## DESIGN RECOMMENDATION

71-72 Union Square

OCTOBER 8, 2020

**Option #1 (multiple views)**

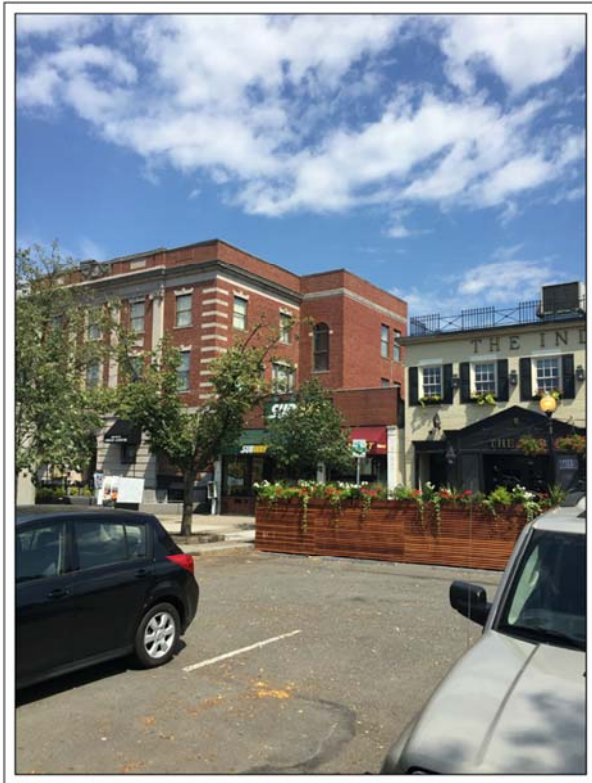
The Commission voted unanimously (3-0) to recommend façade design option #1. The Commission voted unanimously (3-0) to recommend that the Planning Board consider design guidelines 6.2.12.a.ii and 6.2.12.a.iv (with specific attention to the building's pilasters) as a priority for the proposed building. The Commission voted unanimously (3-0) that all of the CC5 design guidelines have been met to their satisfaction by the Applicant's preferred façade design option and preferred ground floor elevation. No recommendation was provided for any modifications to the preferred façade design option. The commission discussed some façade design details, such as the buildings signage and canopy, but did not provide any recommended changes.

<b>CC4 – COMMERCIAL CORE 5 DISTRICT</b>			
<b>LANGUAGE</b>	<b>SATISFIED?</b>	<b>PRIORITY?</b>	<b>NOTES</b>
Facades should be visually divided into a series of architectural bays that are derived, in general, from the building's structural bay spacing.	YES (3-0)		
<b>Piers, pilasters, or other features defining each architectural bay should either extend all the way to the ground or terminate at any horizontal articulation defining the base of the building.</b>	<b>YES (3-0)</b>	<b>YES</b>	<b>The Commission identified this design guideline as a priority consideration for the further evolution of the façade through design development.</b>
Architectural bays should align, in general, with individual or groups of storefronts and lobby entrances.	YES (3-0)		
<b>Piers, pilasters, or other features defining each architectural bay should always project forward and be uninterrupted by any horizontal articulation, excluding any horizontal articulation used to differentiate the base of the building.</b>	<b>YES (3-0)</b>	<b>YES</b>	<b>The Commission identified this design guideline as a priority consideration for the further evolution of the façade through design development.</b>
